SERVICE BULLETIN

POWER PLANT - ENGINE-AIR-FIRE DETECTION, MOUNTING BRACKET - REPLACEMENT OF - CATEGORY
CODE 4 - MOD.ENG-71-0021

V2500-ENG-71-0021

Removal/Installation of the Fire Detection Bracket
Fig.1

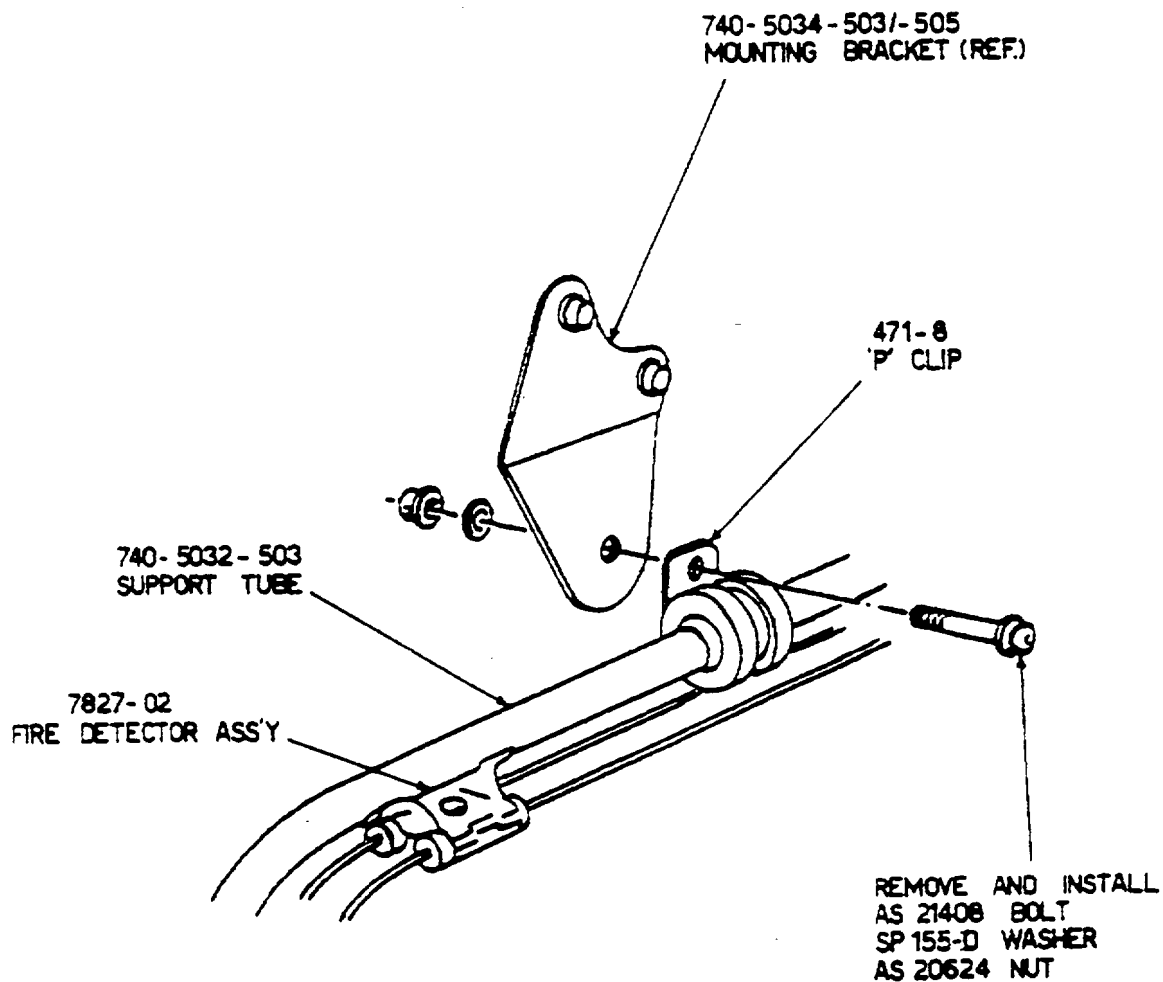
- (1) Open the thrust reverser halves as specified in the V2500 Aircraft Maintenance Manual, Task 78-32-00-010-010.
- (2) Find the D1876-1000A No. 4 bearing compartment air cooler on the bottom of the engine core. (Refer to Figure 1.)
- (3) Find the 740-5034-503 mounting bracket which is attached to the flange of the 5A9038 cold air buffer tube. This tube is installed to the No. 4 bearing compartment air cooler.

- (1) Replace the 740-5034-503 mounting bracket as follows:
 - (a) Release clipping point 5500 which holds the 740-5032-503 support tube of the 7827-02 fire detector assembly to the 740-5034-503 mounting bracket. Remove the AS21408 bolt, the SP155-D washer, and the AS20624 nut which attach the 471-8 'P' clip to the mounting bracket. Let the 471-8 'P' clip stay on the 740-5032-503 support tube. (Refer to Figure 2.)

The 740-5034-503 is replaced by the 740-5034-505 fire detection mounting bracket. The new bracket has a changed contour which will give clearance between the bracket and the 5A9038 cold air buffer tube.
